Docket No. 50-255

The Commission has issued the enclosed Amendment No. 8 to the Provisional Operating License No. DPR-20 for the Palisades Plant. This amendment includes Change No. 12 to the Interim Special Technical Specifications (Amendment 4 to the License) and is in response to your request dated April 18, 1974.

Amendment No. 8
License No. DPR-20

CHANGE NO. 12 TO THE INTERIM SPECIAL TECHNICAL SPECIFICATIONS

FIGURE B-2
ALLOWABLE LINEAR HEAT RATES
IN PALISADES REACTOR

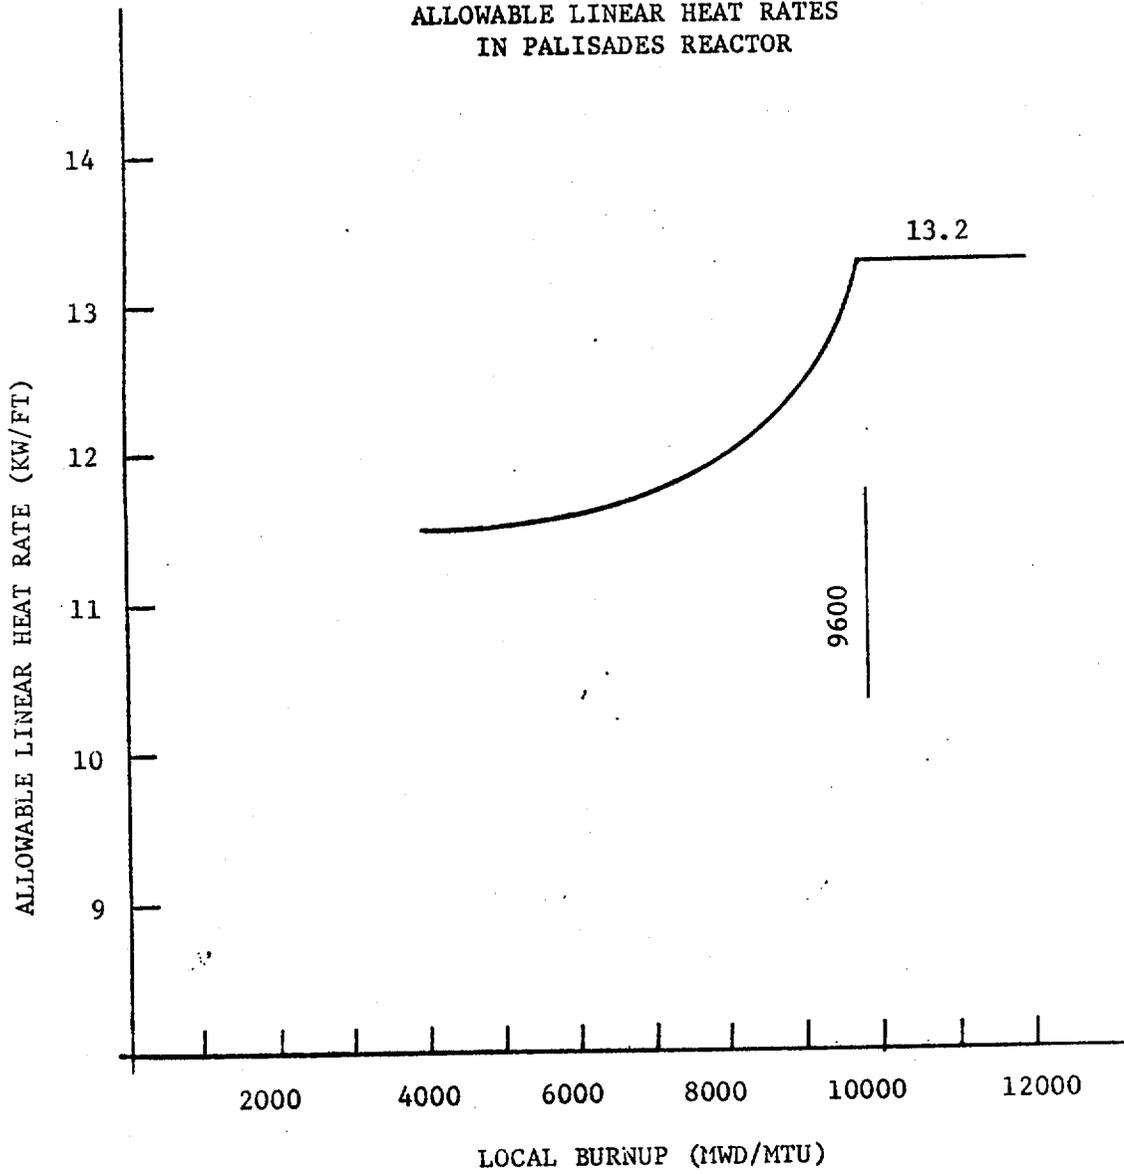
- A. Change "10,300 Mwd/MTU" in Items 3 and 5 to "10,265 Mwd/MTU."
- B. Change Item 3.a to read as follows:
- "a. The peak linear power with appropriate consideration of normal flux peaking, flux peaking augmentation factors, measurement-calculational uncertainty (10%), engineering factor (3%), increase in linear heat rate due to axial fuel densification (1.75%) and power measurement uncertainty (2%), shall not exceed the kW/ft limit shown in Figure B-2 for unpressurized fuel and 11.5 kW/ft for prepressurized fuel (Bundle B-69)."

- D. Add Sheet containing Figure B-2 titled "Allowable Linear Heat Rates in Palisades Reactor".
